CORRIGENDUM-III

RFP ENQ. No.- OCAC-NEGP-INFRA-0007-2021-22061 Dated 23.08.2022, for Selection of Agency for Implementation, Operations and Maintenance of OSWAN NOC

Revised Request for Proposal (RFP) for Selection of Agency for Implementation, Operations and Maintenance of OSWAN NOC

6.3. OSWAN-NOC Layout:

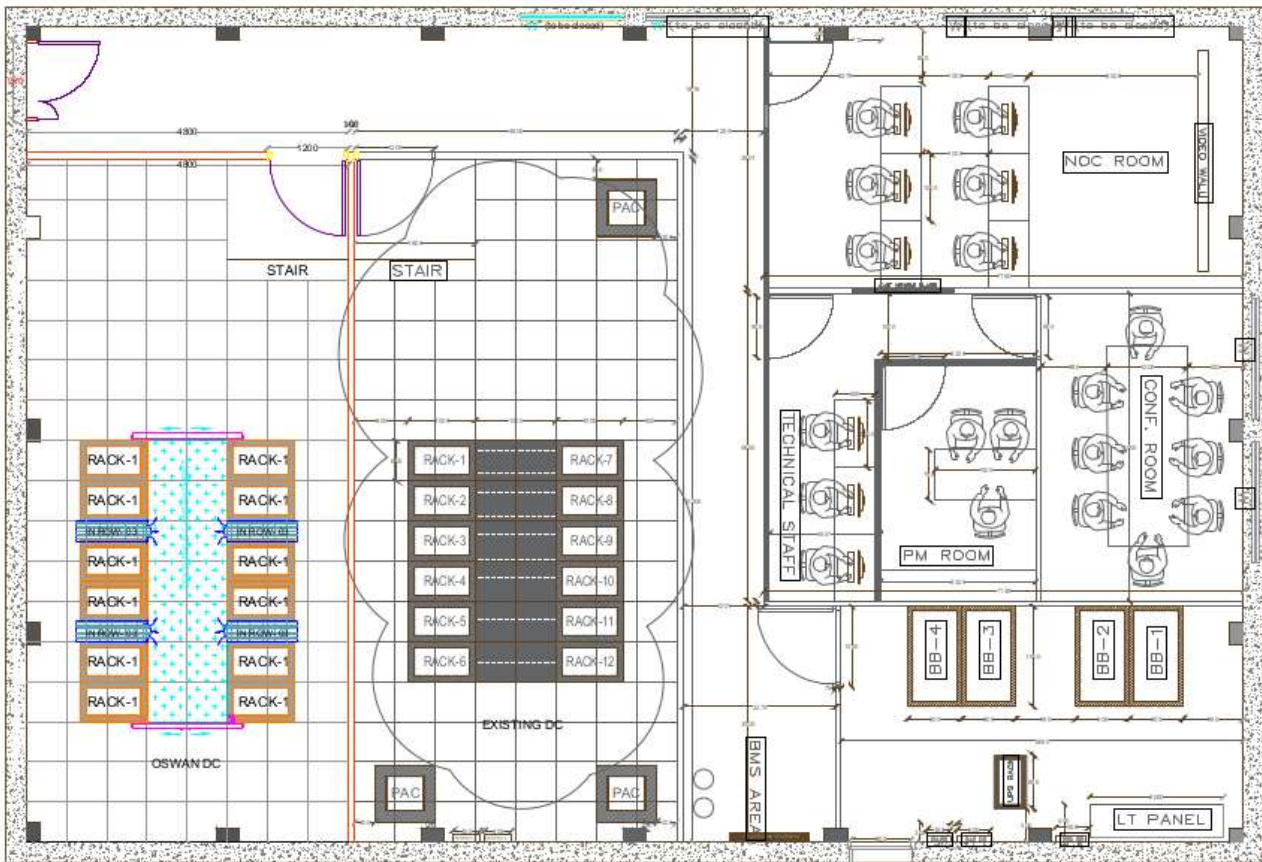
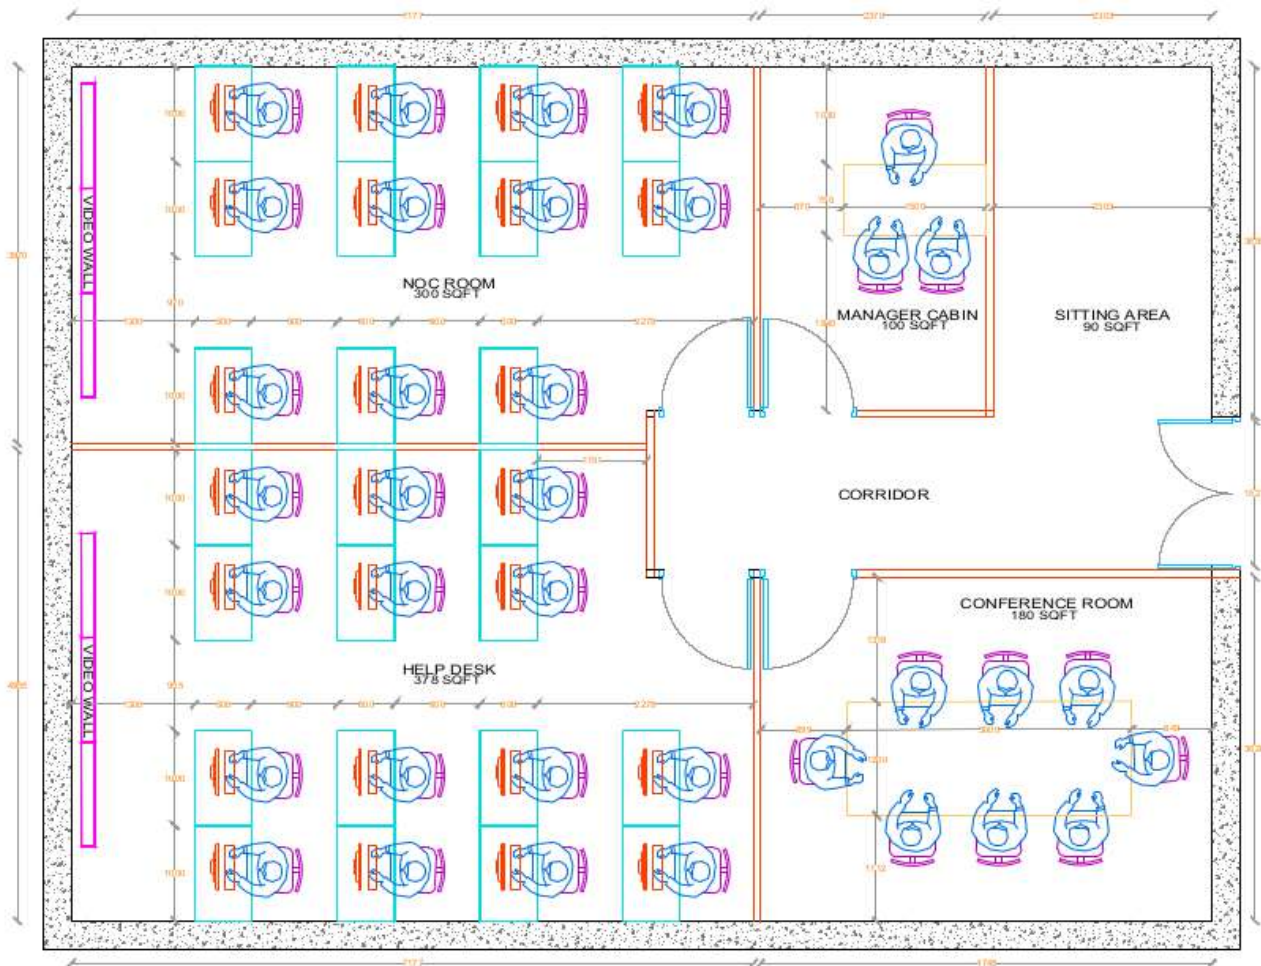
Sr. No.	Page No	Clause No	RFP Clause	Query /Clarification/ Suggestion if any asked		Modification/ Addendum/ Deletion/ Clarification
107.	36,37		The diagrams and layout are on the page 36 and 37	Is OSWAN NOC Room, Office Area Layout and OSWAN Helpdesk Room is final as per the OSWAN RFP doc ?		Clarification: It may change as per the space availability and as best practice of bidder solution.
